**Glacier Power Ltd.
Dunvegan Hydroelectric Project
Fairview, Alberta**

**EUB Application No. 2000198
NRCB Application No. 2000-1**

**Report of the EUB-NRCB
Joint Review Panel**

**Report of the EUB-NRCB Joint Review Panel
Dunvegan Hydroelectric Power
Glacier Power Ltd.
EUB Decision 2003-020**

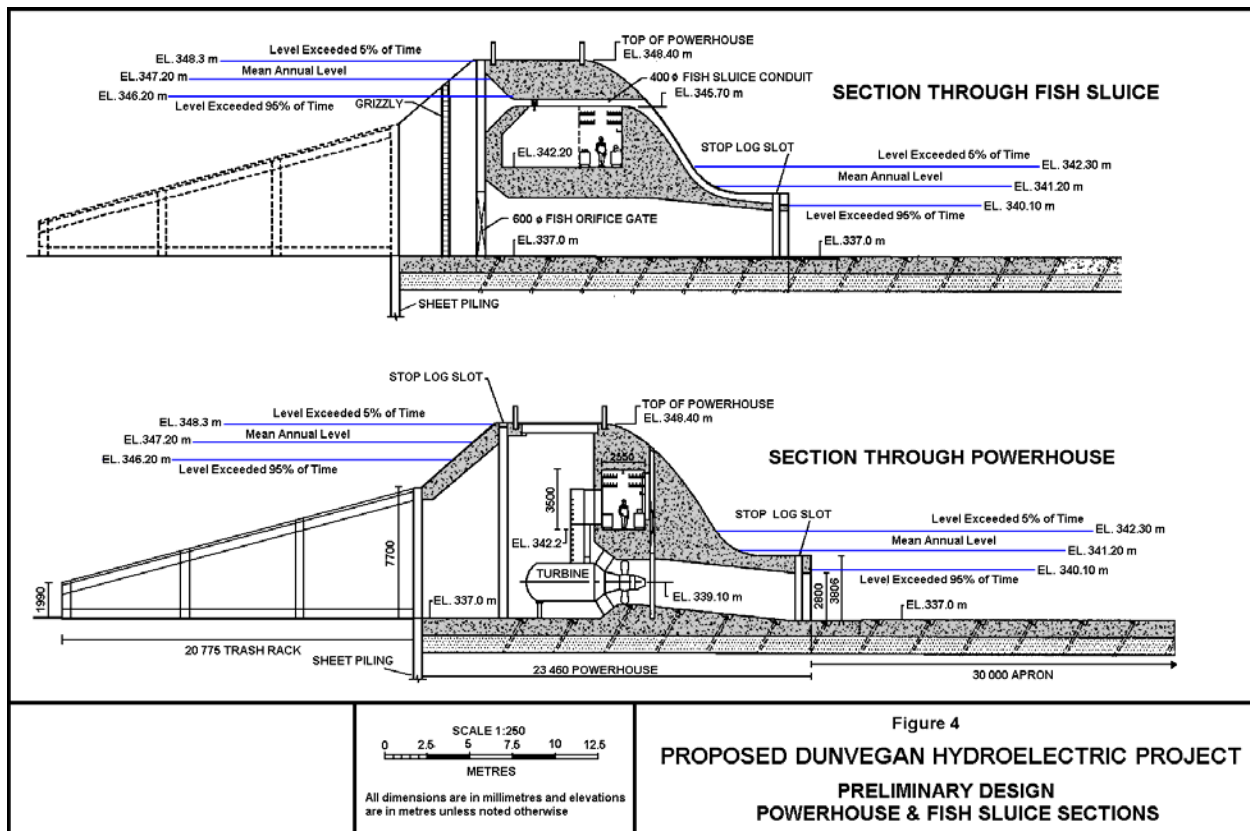
In addition, the Panel shares the concerns raised by the Friends of the Peace regarding behavioural avoidance of the fishway entrance and the ability of fish smaller than 150 mm to move through the structure. The Panel also has concerns about potential impacts on fish populations, such as burbot, that move upstream during the winter months, since the fishways would not be operating during December through March. This latter issue is particularly problematic because available evidence on fish movement patterns in the vicinity of the weir on either a seasonal or annual basis is very limited.

The Panel also notes that the proposed fishway is significantly narrower than the river margin where upstream fish migration is currently predicted to occur and, furthermore, that Glacier itself accepts that hydraulic conditions differ significantly between the two banks. Therefore, without Glacier having completed additional design work on the fishway at the north bank and an assessment of the effectiveness of this design to attract and pass fish, the Panel is unable to gauge the potential impact of the project on upstream fish movements along the north shore of the Peace River.
